FRAMATOME ANP

***Revisions to
“MOX Fuel Design Report”
Kevin McCoy***

White Flint, MD, June 24, 2003

Advanced Mark-BW Design Features

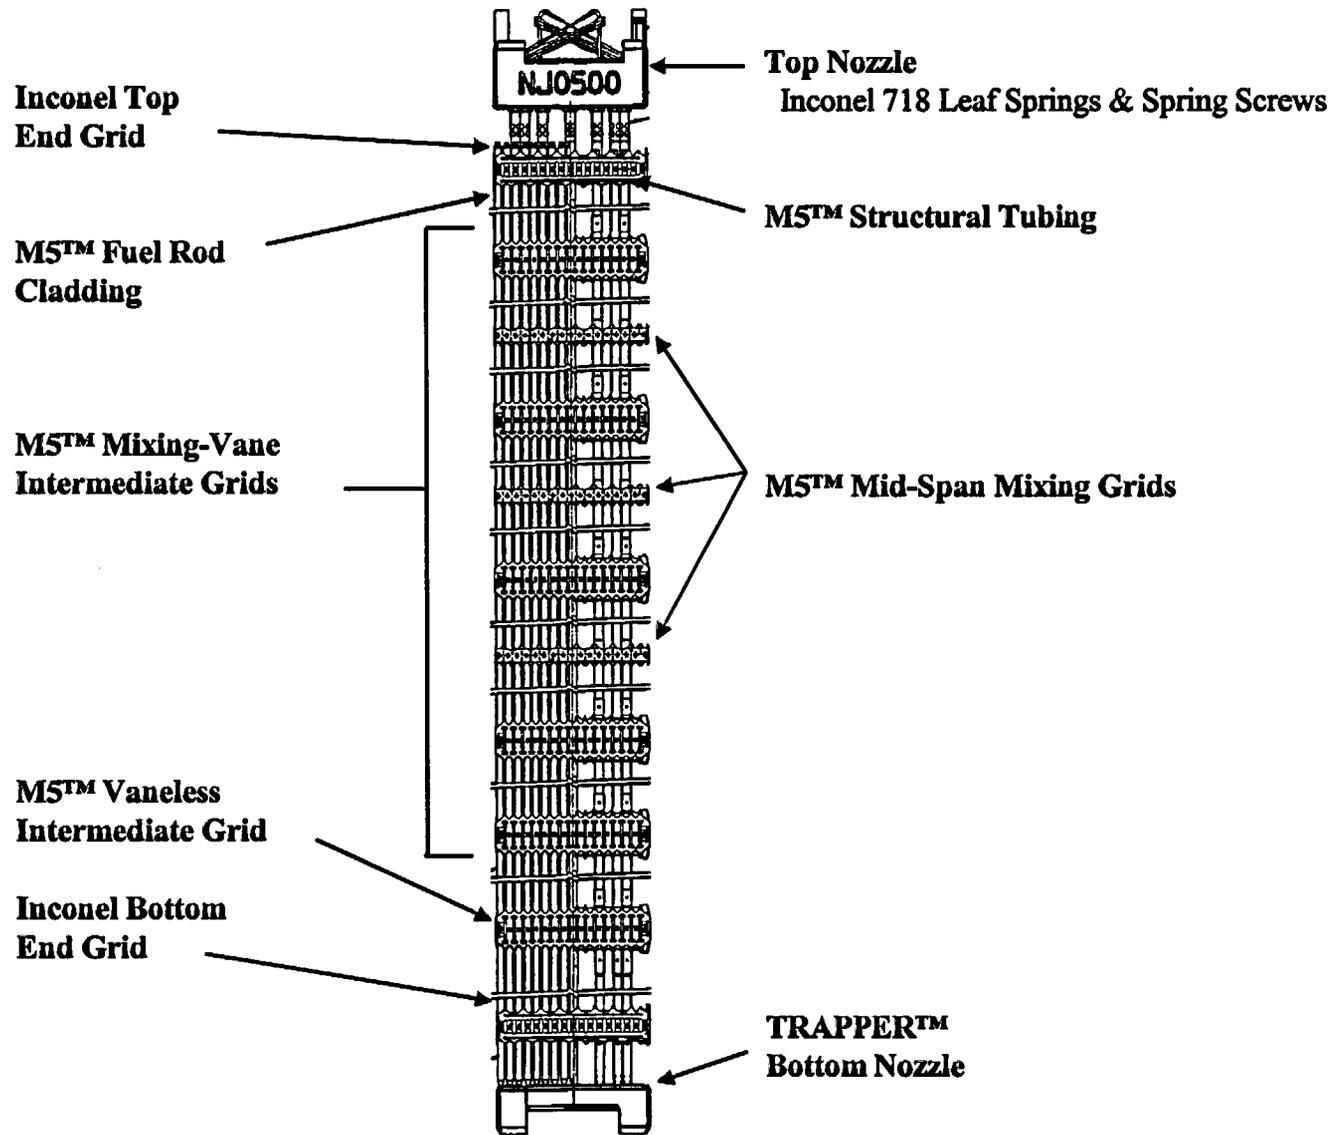
- > ***MOX fuel assembly design is the Advanced Mark-BW design with WG MOX pellets***
- > ***Changes to report are minor:***
 - ◆ ***Corrected terminology for mid-span spacer grids***
 - ◆ ***Increased burnup limit for Advanced Mark-BW (not Mark-BW/MOX1) to reflect recent submissions***
 - ◆ ***Adjusted precision of some values***
 - ◆ ***Moved discussions of Pu isotopics to Chapter 3***
